C-E Power Systems
Combustion Engineering, Inc.
Route 21-A
Hematite, Missouri 63047

License SNM-33
Docket 70-36

Enclosed are eight copies of Drawing D-5008-2023, which were omitted from our application dated June 19, 1981 for dry powder storage on conveyors and mezzanine storage of agglomerated press feed.

D-5008-2023

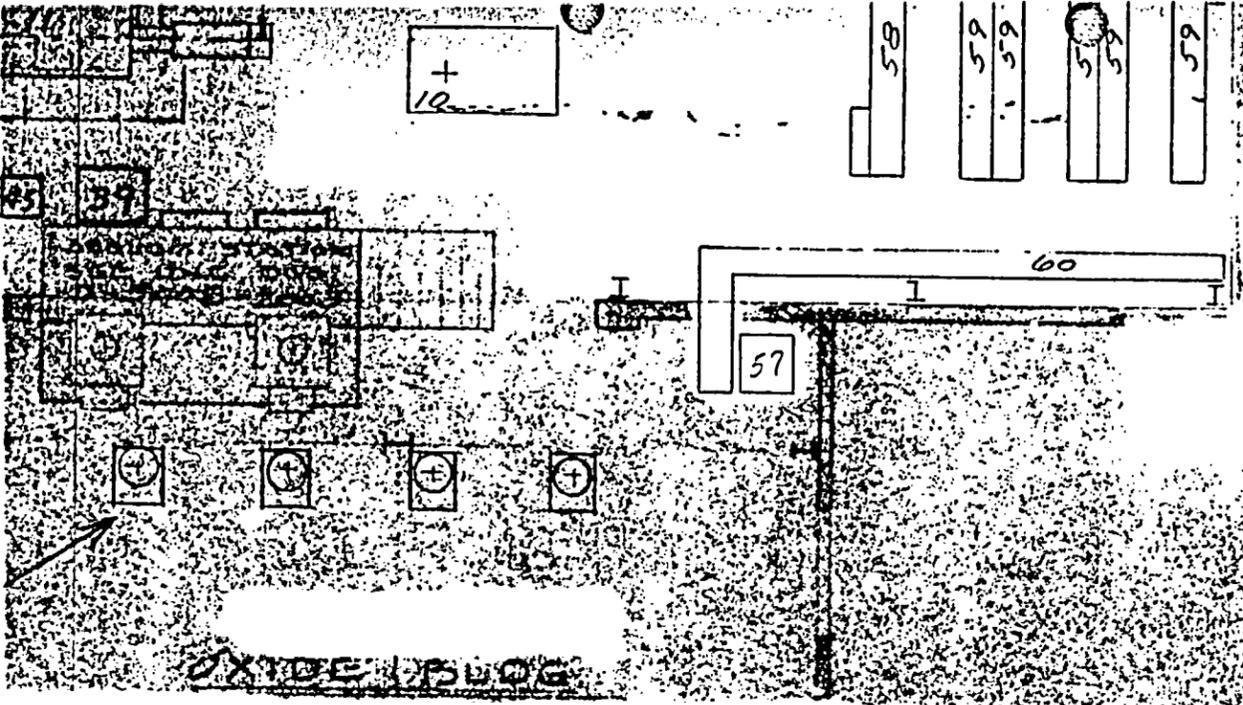
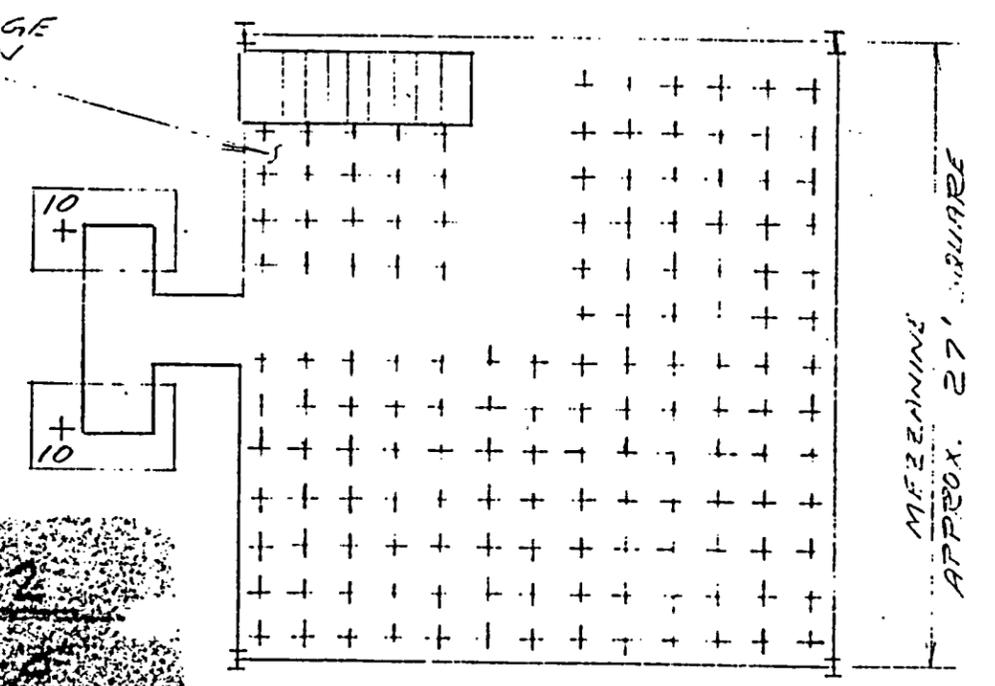
In addition, page 8-7 has been revised to show the correct drawing number.

The sealed cans of dry UO_2 product are then transferred to one of 5 roller conveyors on the north side of Building #255 as shown in Items 58, 59 and 60 of Drawing D-5008-2023, dated 2/5/81. The entire building is above the 100 year flood level as determined by the U. S. Army Corps of Engineers in their Special Study for Joachim Creek, dated March 1980. Even if flooding were possible, the 30 Kg weight of the cans containing high density UO_2 would prevent them from floating and being moved. Building #255 is not sprinklered and firefighting would be by dry chemical means. Thus, criticality safety is assured through moderation control (\leq 4.1% enriched UO_2 cannot be made critical without moderation).
